Tindell Park

Tindall Road Middletown, NJ

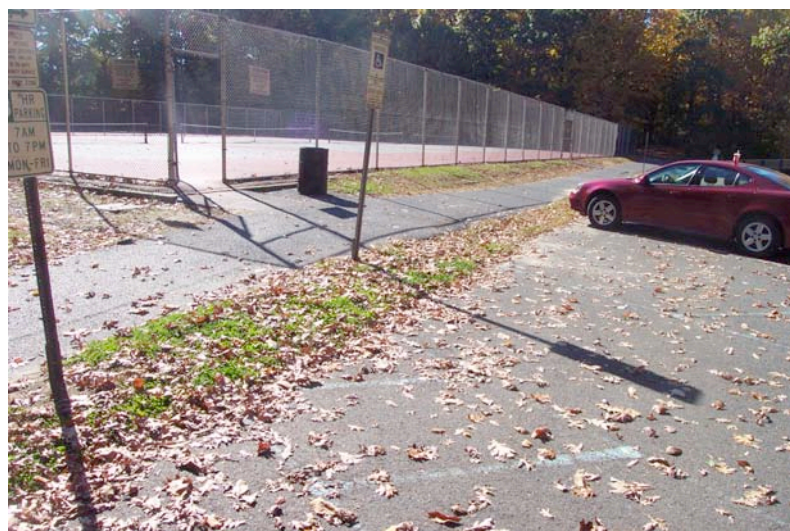
1. The parking area in front of the park has several problems to be corrected.
 - a. The parking spaces have running slopes of between 4.6% to 4.8%. There is a dip in each space which gives the excessive incline, contrary to ANSI section 502.4 and ADAAG section 4.6.3.

- b. The bottom of the signs at each space is below 60 inches when measured above the ground surface contrary to ANSI section 502.6 and ADAAG section 4.6.4.
- c. There is no accessible route from the access aisles to the sidewalk contrary to ANSI section 502.3 and ADAAG section 4.6.3.

2. There are picnic tables at this site which have no accessible route of travel to them, contrary to ANSI section 403.2 and ADAAG section 4.5.1.

3. The path of travel to the tennis courts has a ramped surface which has a slope of 7.3% slope, contrary to ANSI section 405.2 and ADAAG section 4.8.1.

4. There is a 4.4% cross slope on the sidewalk in front of the tennis courts, contrary to ANSI section 305.2 and ADAAG section 4.3.7.

5. There is a 1 inch transistion into the tennis court, contrary to ANSI section 303.2 and ADAAG section 4.5.2.

6. The ramp to the playground has a slope of 10.9%, contrary to ANSI section 405.1 and ADAAG section 4.8.2.

7. The ramp to the playground lacks a landing with less than a 2% slope, according to ANSI section 405.7 and ADAAG section 4.8.4..

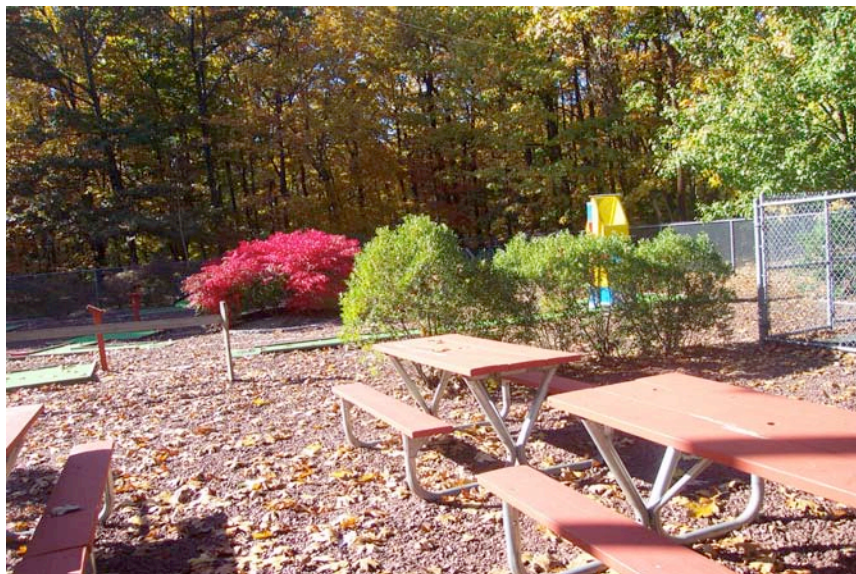
8. At the end of the sidewalk there is no curb cut, contrary to ANSI section 303.4 and ADAAG section 4.7.1.

9. The parking spaces at the golf course do not have maintained paint and striping, contrary to ANSI section 502.3.3 and ADAAG section 4.6.4.
10. The parking area at the miniature golf course needs an access aisle added to one space, contrary to ANSI section 502.3 and ADAAG section 4.6.3.

11. There are 10 tables at the golf course, none of which are accessible with 19 inches of underside clearance and 30 inches by 48 inches of clear floor space, contrary to ANSI section 902.2 and ADAAG section 4.32.3.

12. The counter at the miniature golf course is higher than 36 inches without a lowered section of 60 inches, contrary to ANSI section 904.3 and ADAAG section 7.2.

13. There is no access around the golf course because there is no hard ground surface contrary to ANSI section 302.1 and ADAAG section 4.5.1. There is also a transition more than .25 inches from the entrance to the concrete pad in front of the service window.

14. There is no access into the basketball court, contrary to ANSI section 402.1 and ADAAG sections 4.1.3(1) and 4.5.2.

15. There are no designated disabled parking spaces at the basketball court, contrary to ANSI section 502.2 and ADAAG section 4.6.1.
16. There is no access from the parking area to the basketball courts, contrary to ANSI section 502.3 and ADAAG section 4.6.3.
17. There are no curb cuts at the basketball courts, contrary to ANSI section 303.2 and ADAAG section 4.7.1.
